CITY OF ALBUQUERQUE

**Re: Assisted Living Home, 7500 Oakland Ave NE
Grading and Drainage Plan
Engineer's Stamp Date 2-2-15 (C19/D062)**

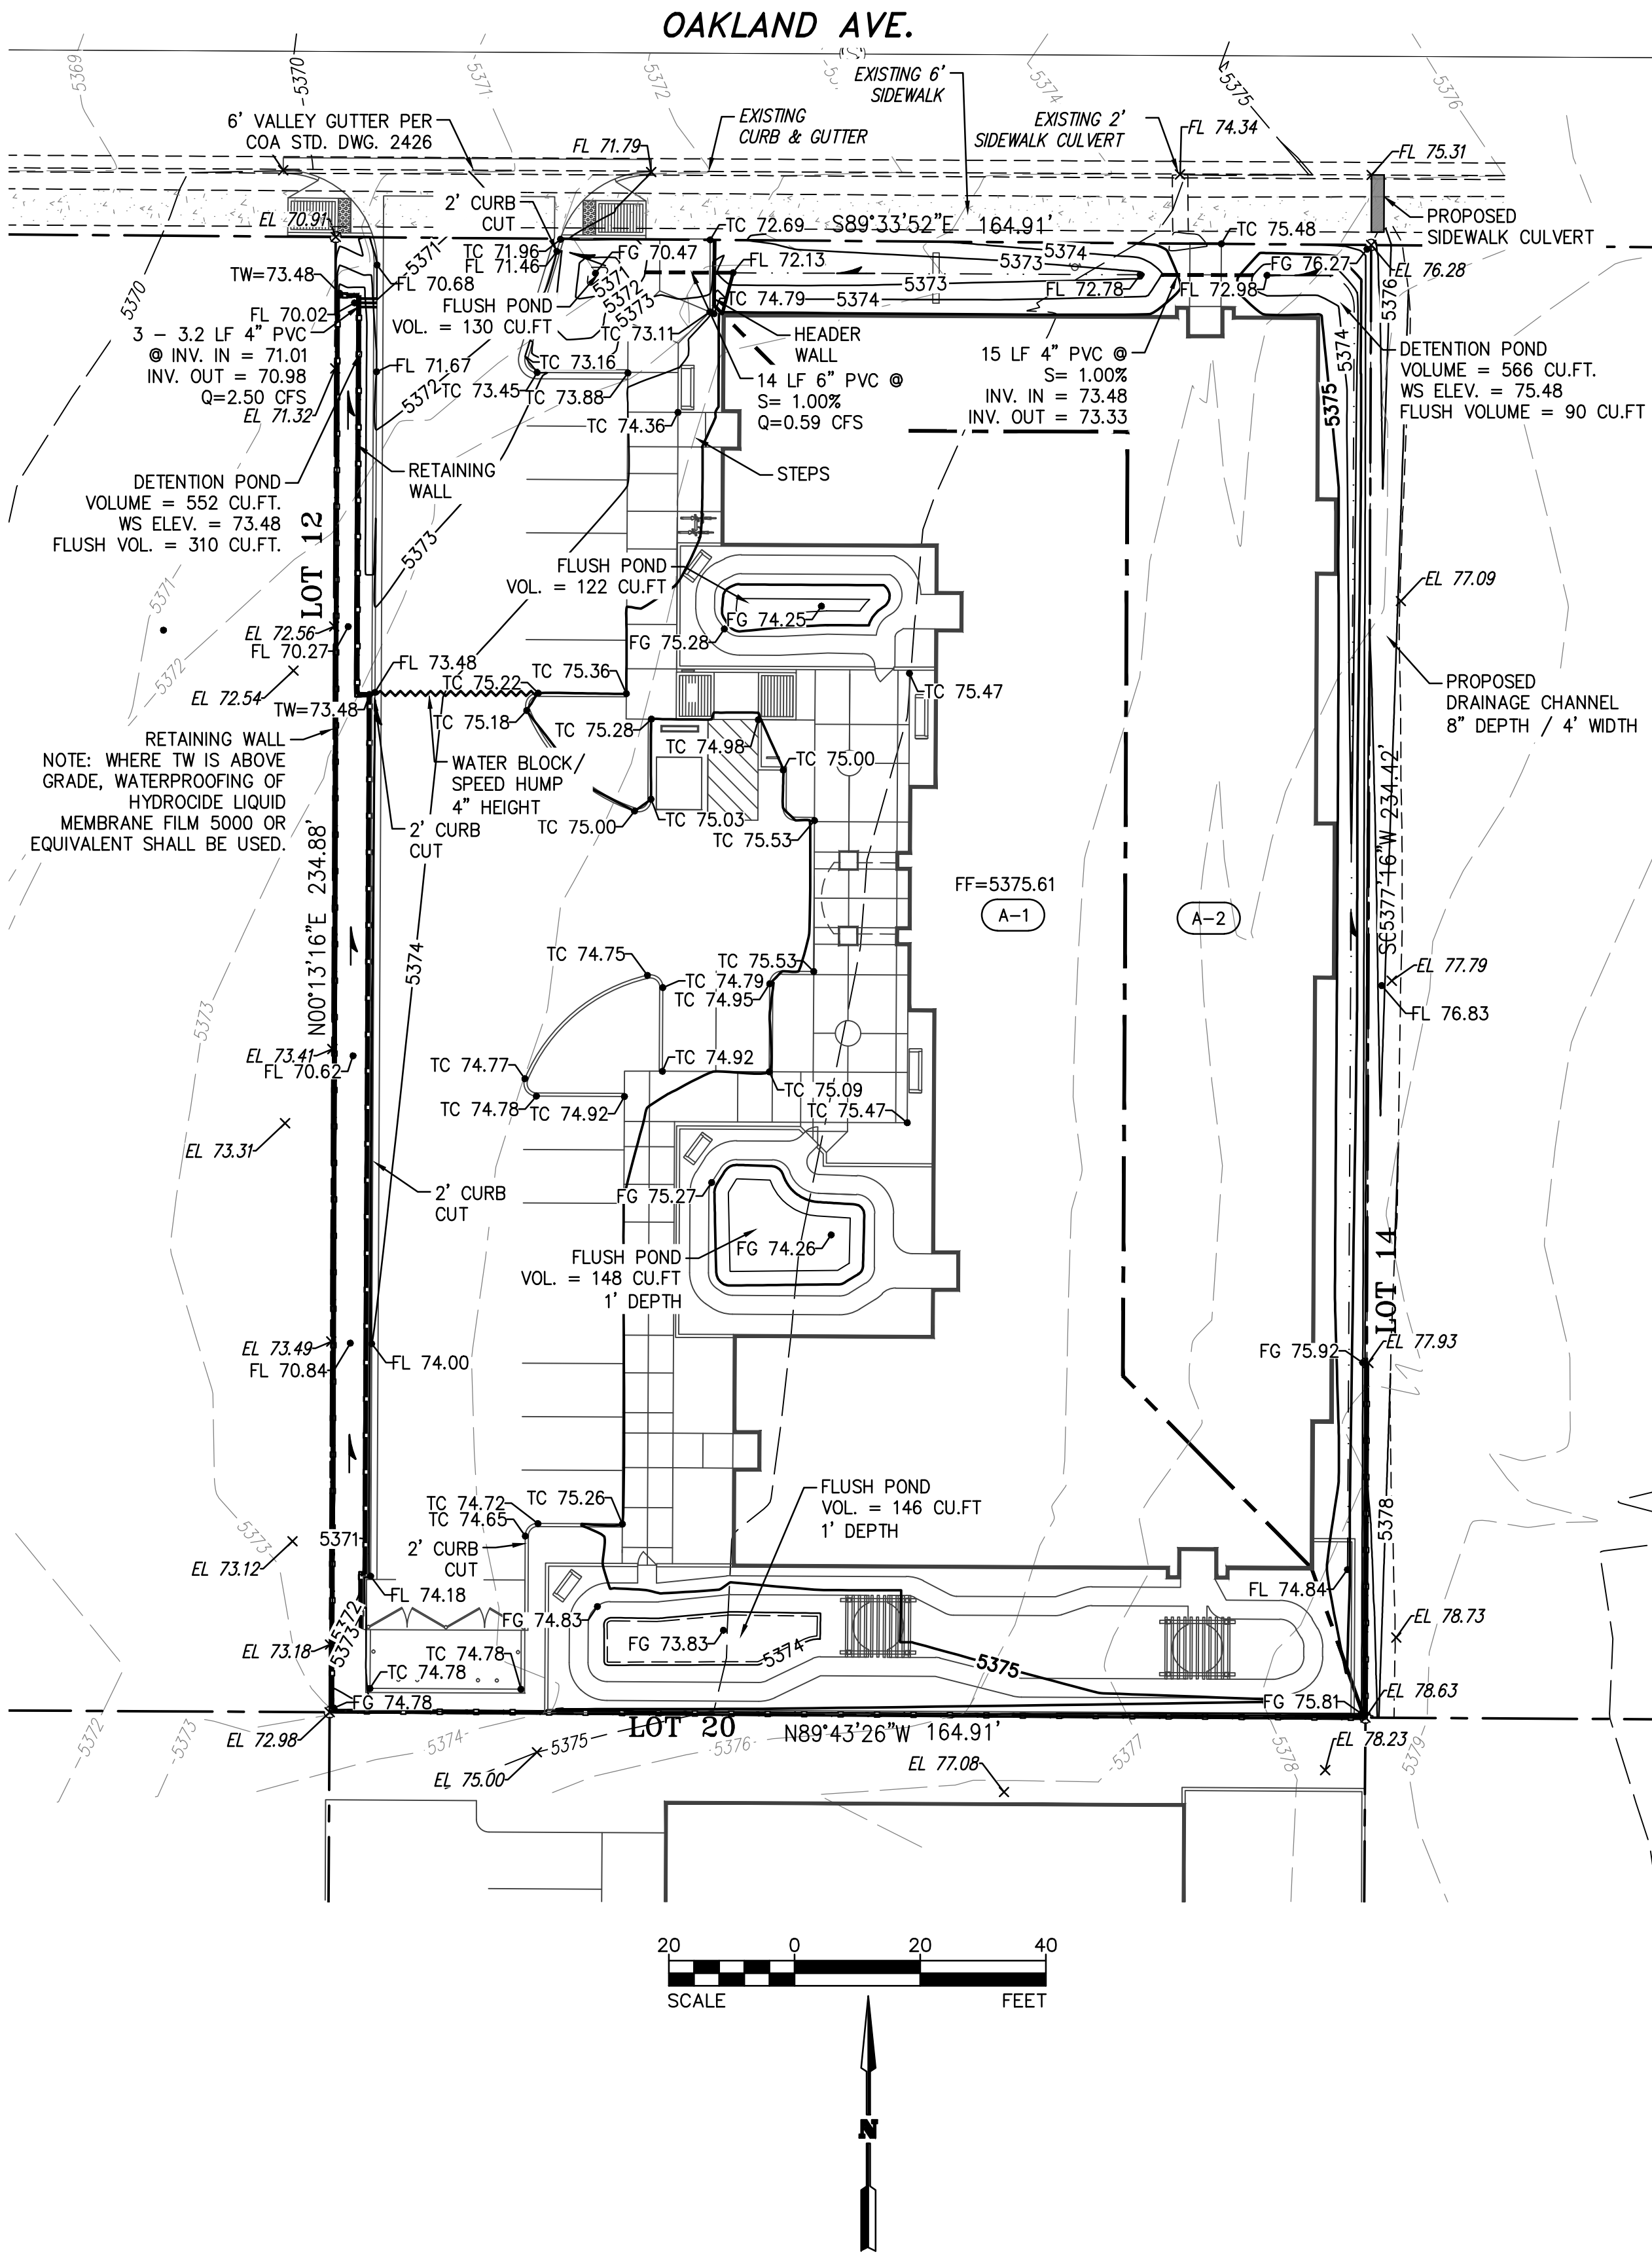
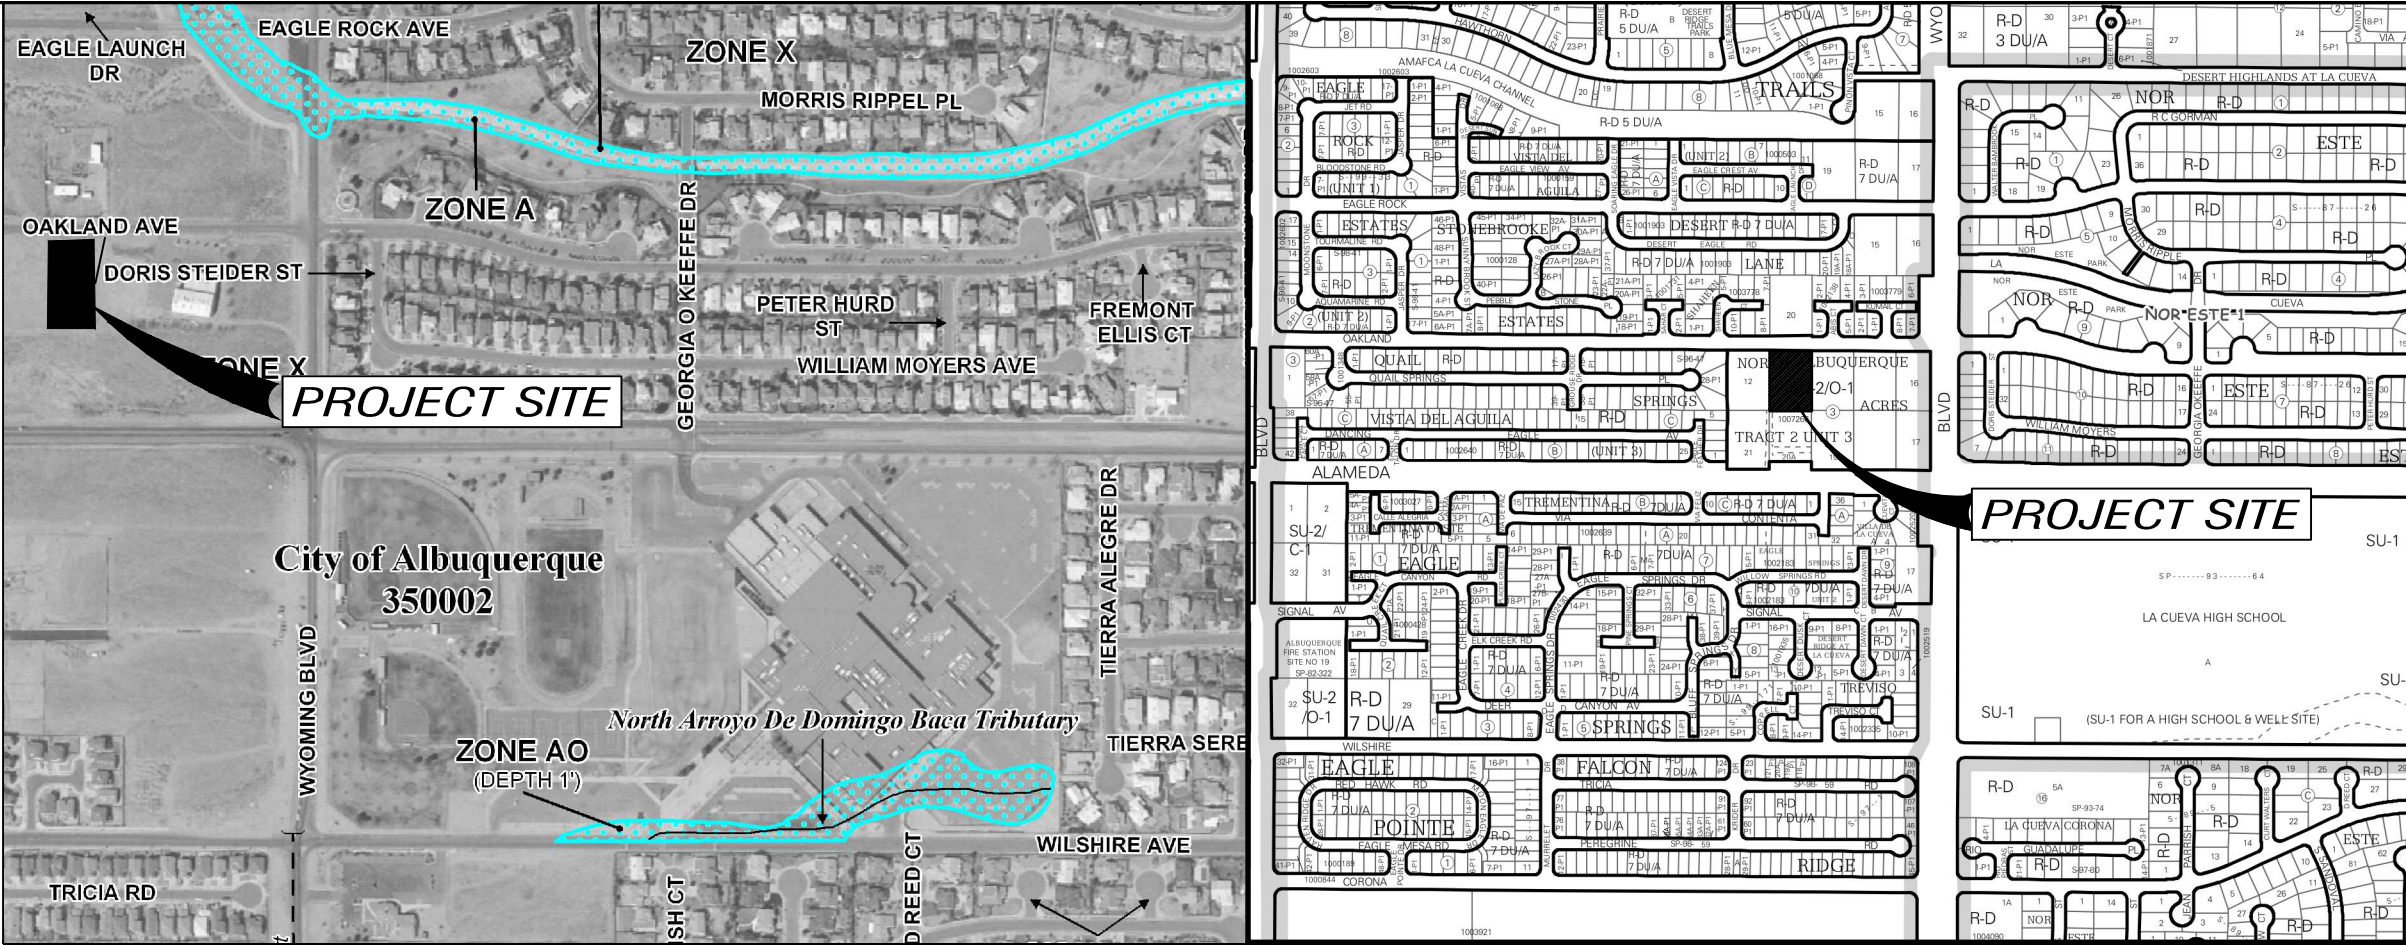
1. The application is to request SO-19 approval and provide the appropriate notes. A second copy of the plan is required as one copy goes to the DMD inspector.
2. Provide TW/BW grades for the retaining wall(s). Ensure a TW/BW is provided at the terminus of the retaining wall(s).
3. Provide Volume Required, Volume Provided and WSE for the detention pond. The Landscape Plan shows approximately 40 plants in this area. Therefore, the Volume Provided should be larger than the Volume Required by some factor.
4. Provide calculations for the sizing of the detention pond.
5. The monument sign is proposed in the flow line of the drainage swale along the northern part of the building. How is that going to work?
6. The 4" drain under the sidewalk along Oakland Ave seems undersized for 1.2 cfs.
